DDS- Planning & Zoning: Plan Review Application

Please describe your application action(s) and provide as much detail as possible. Attach additional pages if necessary: **special permit for outdoor drinking patio**

HOG RIVER BREWERY RELOCATION
 1420 Park St.
 Hartford, CT 06106

From: Paul Ashworth
Sent: Wednesday, July 13, 2022 3:34 PM
To: Berschet, Paige; Natalie Sweeney
Cc: Hartford Planning Division
Subject: RE: 1420 Park St - Special Permit Application - P&Z-COMM-2022-0264

① SOUTH FACADE

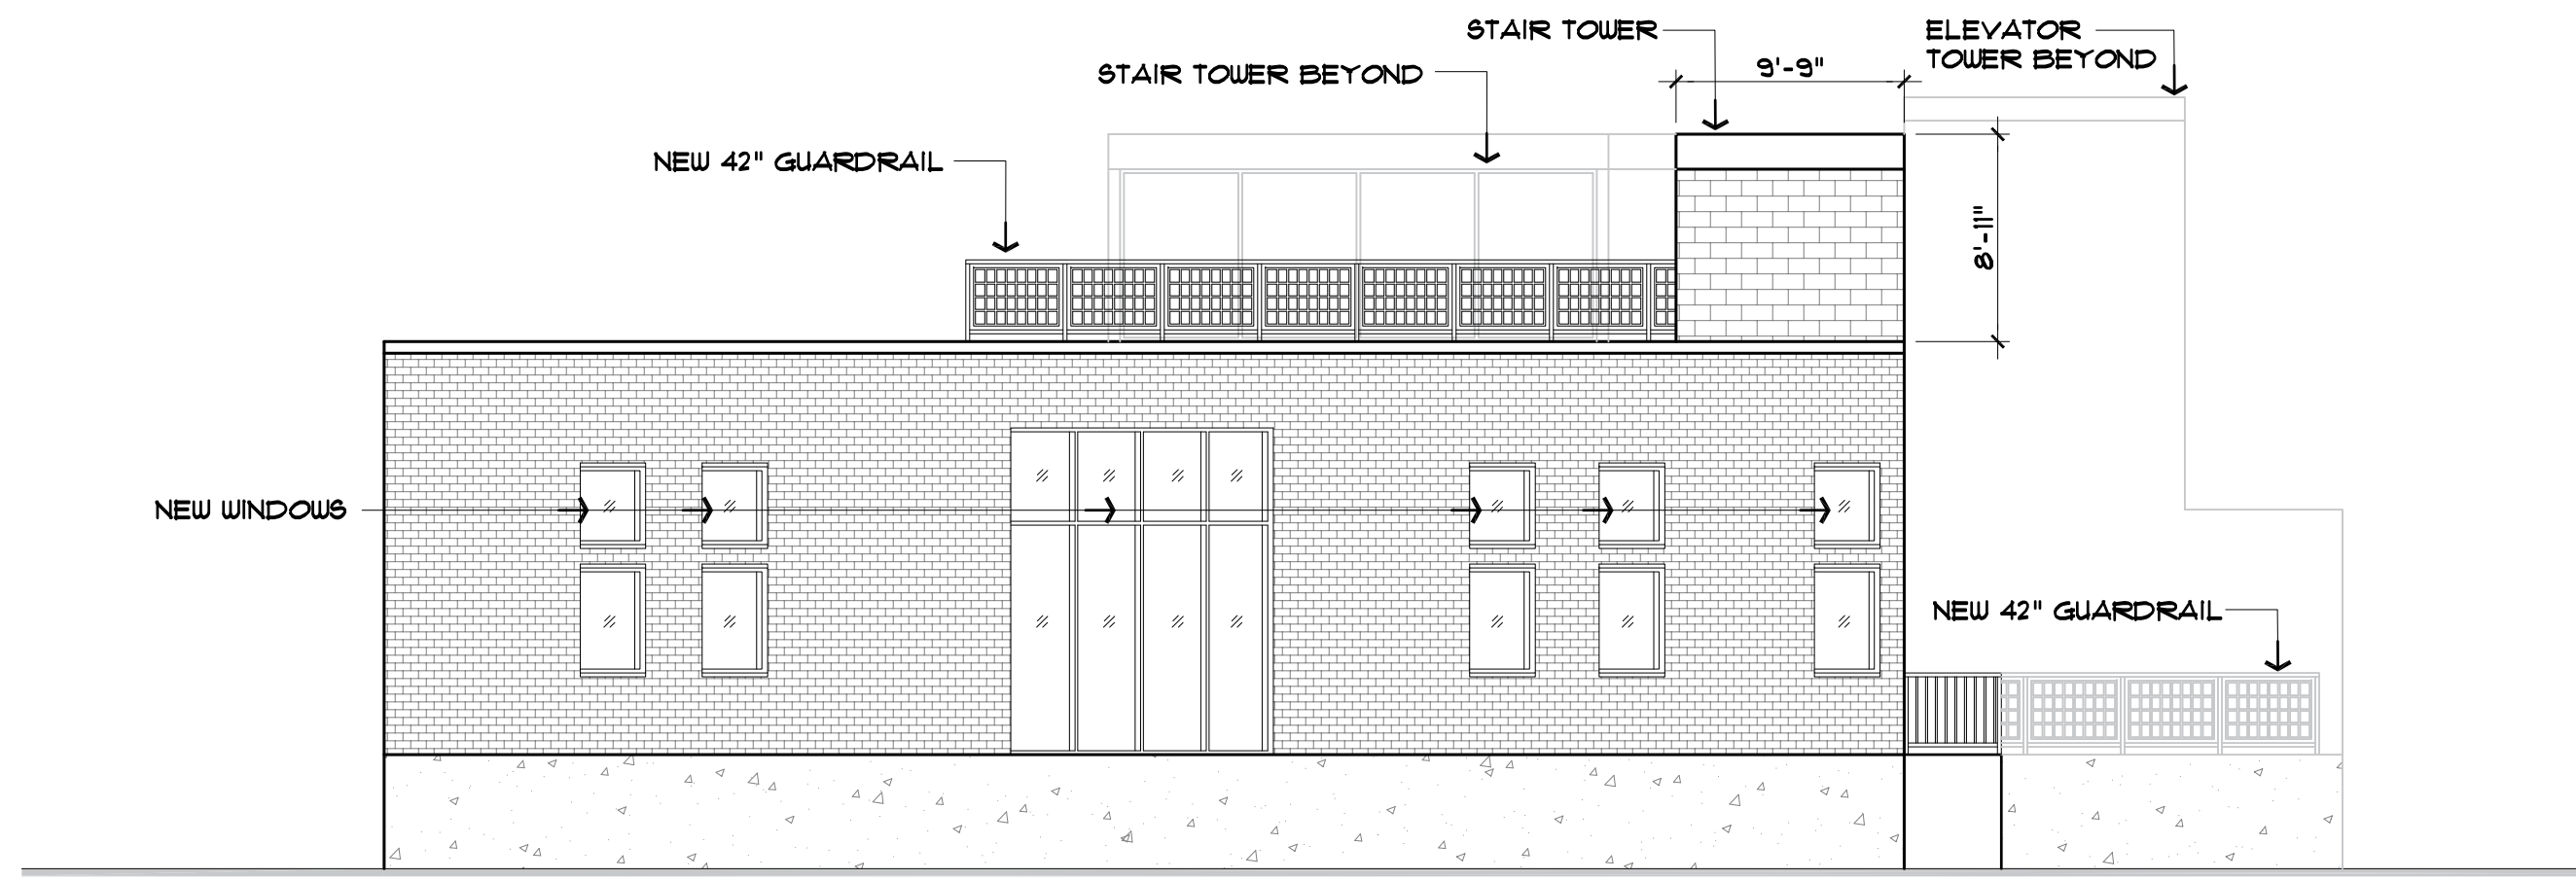
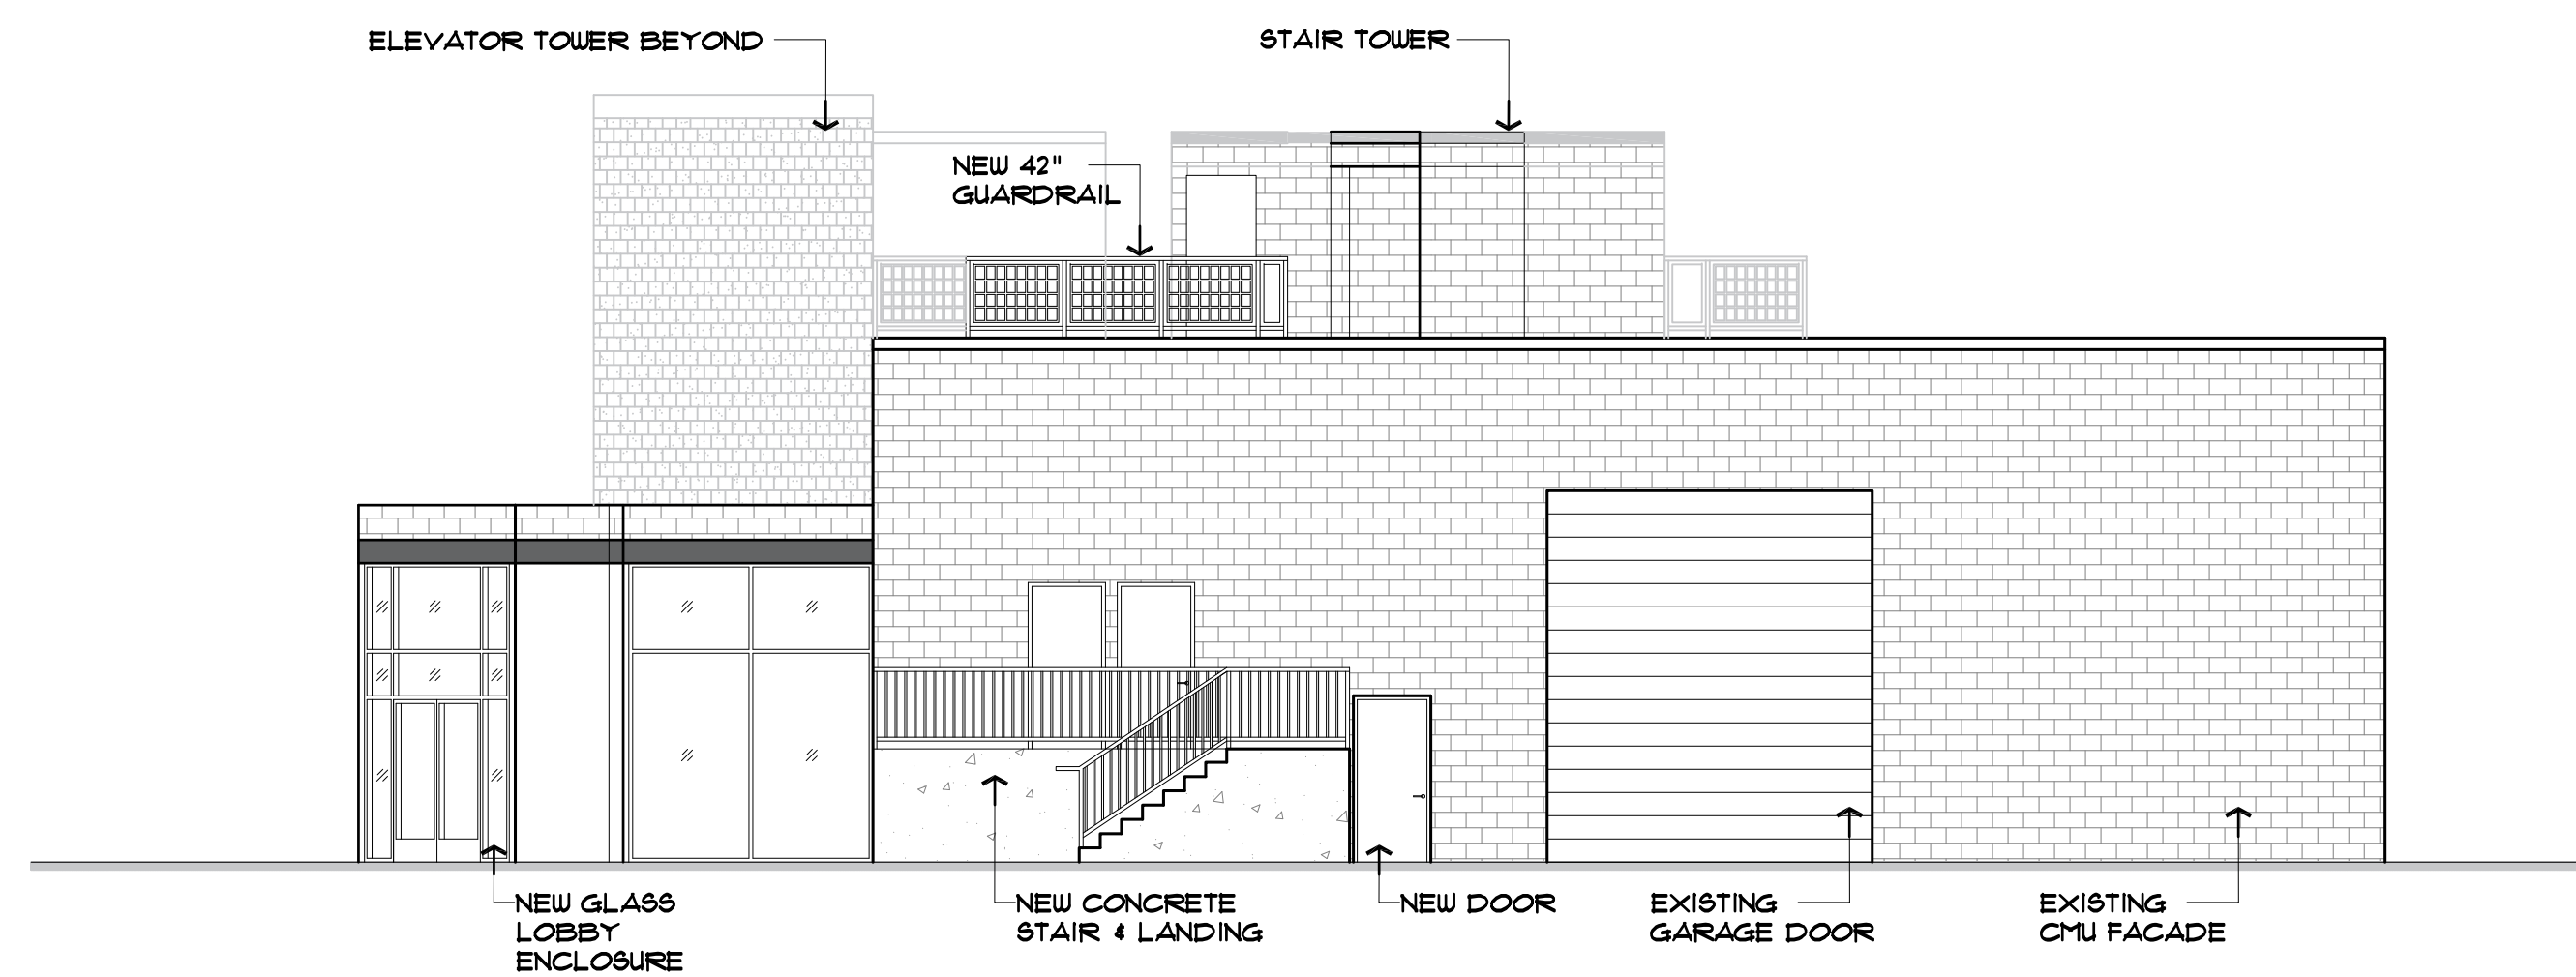
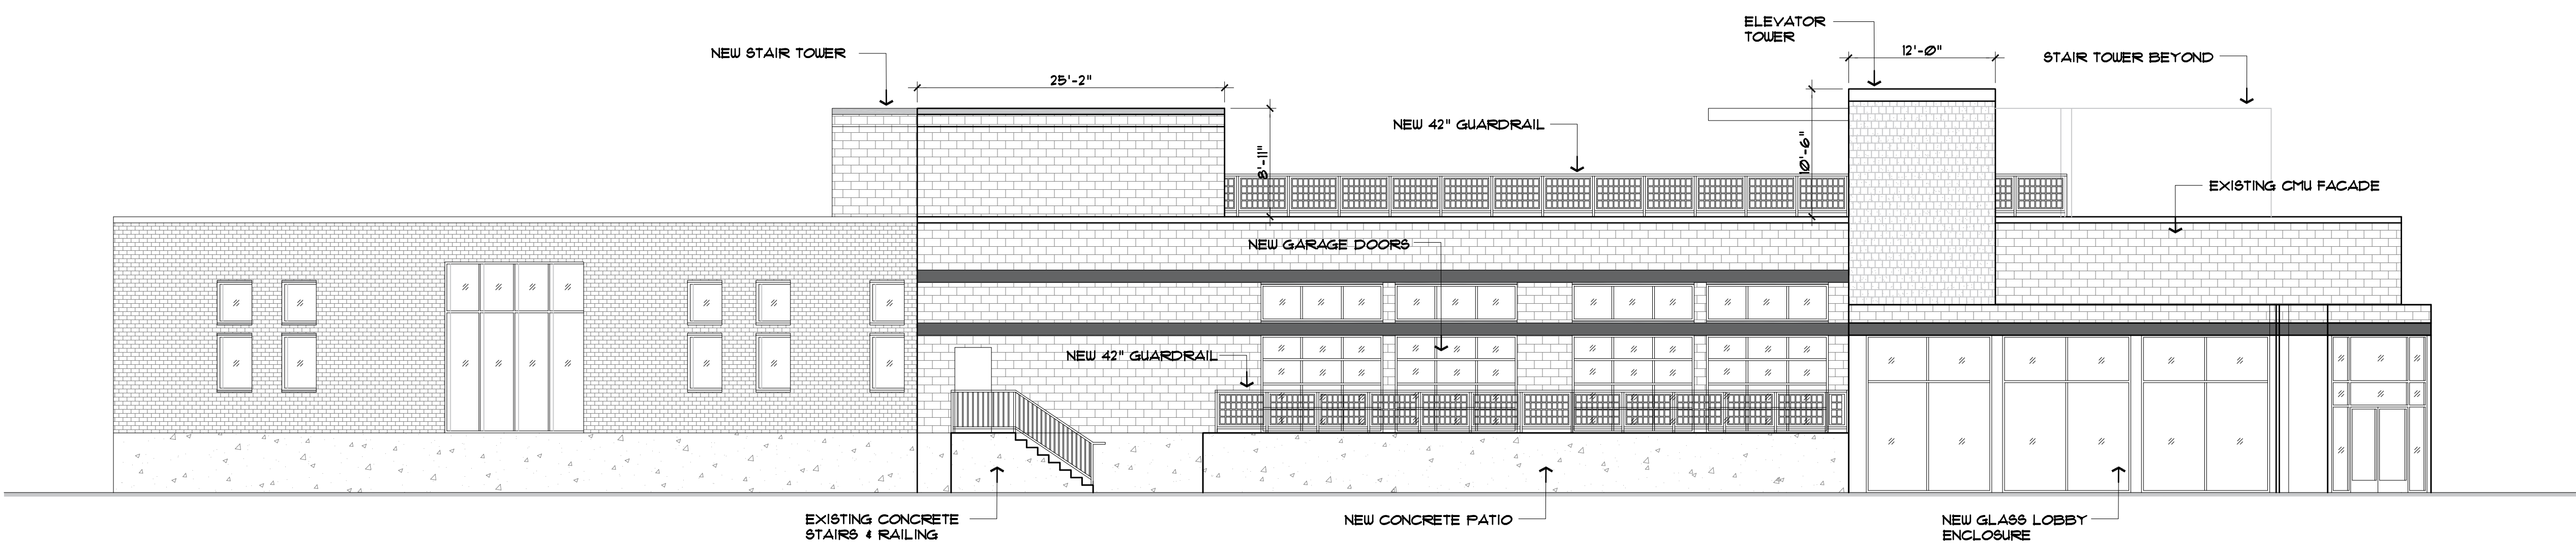
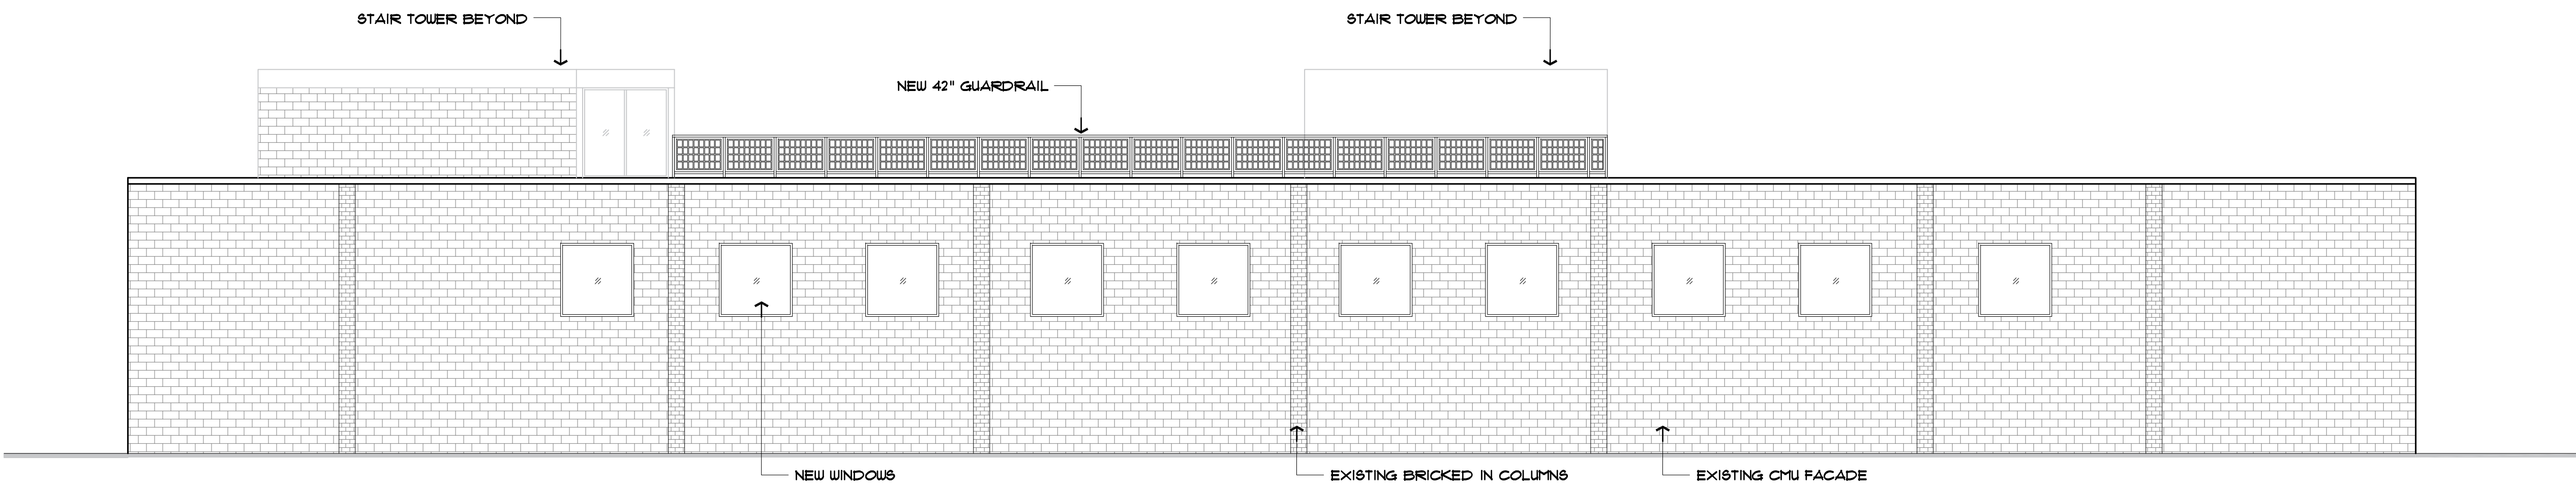
- I noticed that the proposed elevation drawings do not match what was approved by the historic preservation board 12/15/21 (COMM-2021-0548). **Paige Berschet** will confirm whether this will require additional review by HPC.
- What are the proposed hours of operation of the overall craftsman industrial use; what are the proposed hours of operation for the outdoor café (rooftop and front patio area).
- Please provide a square footage table. Please calculate the square footage of the overall use and the outdoor café. Include a calculation of the area devoted to Drinking or eating place. Sec.3.3.7.B requires that at least 10% of the square footage be used as a “showroom” or shop selling the product manufactured on site (drinking place).

Special Permit Comment #3: It has been determined no additional historic review is required because the changes are not substantial and do not represent a change in materials.
